**ADDENDUM NO. 01**

**PROJECT: PIMA COUNTY BIOGAS SALE AND UTILIZATION PROJECT**

**SOLICITATION NO.: 104346**

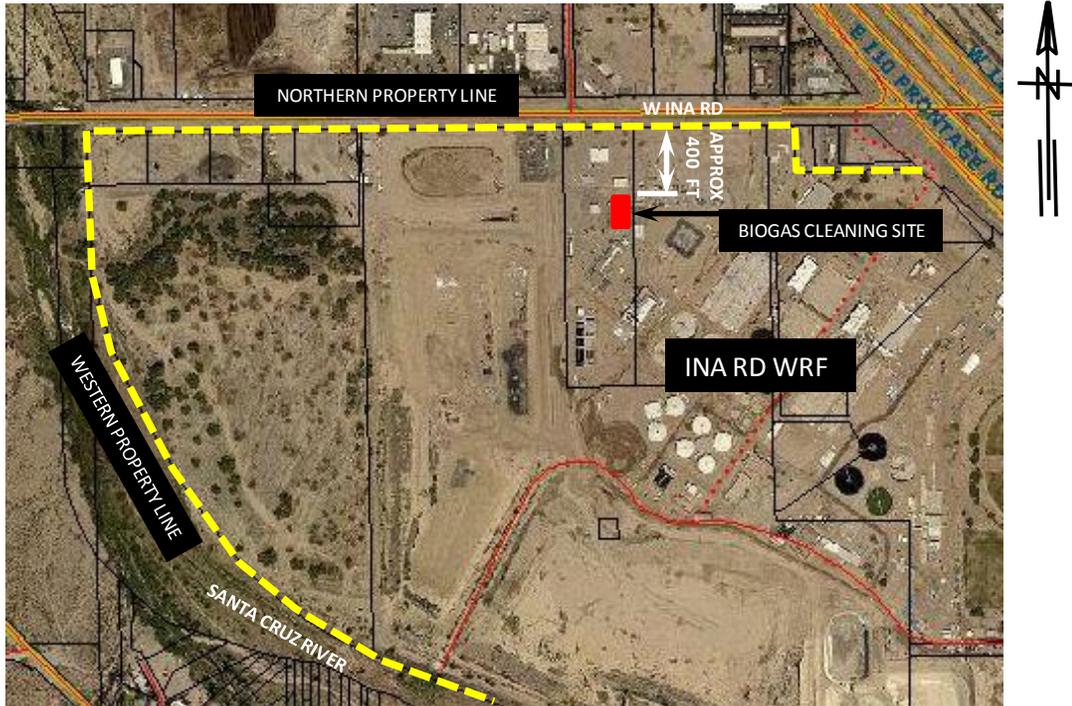
2. Please provide location of County's property line located near the designated site to help assess your audible noise level requirements. We would like to know if the audible noise level requirements can be alleviated to minimize chances of this requirement making the project economically unfeasible?

The County property boundary line is shown in a figure below. The noise level will be measured at the Project Site and at the County property line to prevent the Project noise from exceeding an 80 dBA (summation of all octave bands) sound pressure level at the Project's Lease Premises

boundary, or 50dBA at the County's property line, whichever is more stringent. Distances to the County property boundary is provided below.

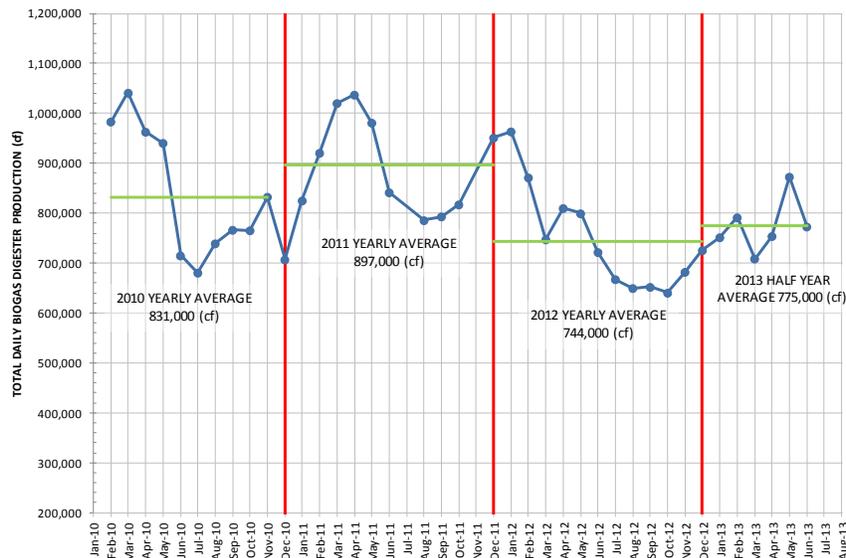
- The digester gas volumes provided between April, 2011 and March, 2013 show a very significant drop. What caused this drop and is this a permanent or temporary drop?

Due to major treatment plant construction temporary biosolids process changes at Ina Road WRF and Roger Road WRF were experienced between December 2012 and April 2013. The construction activities disrupted normal digester operations and in particular the digesters at Roger Road WRF. After April 2013, the digesters at Roger Road WRF were operating normally. Thereafter, biogas production continues at normal expected production rates.
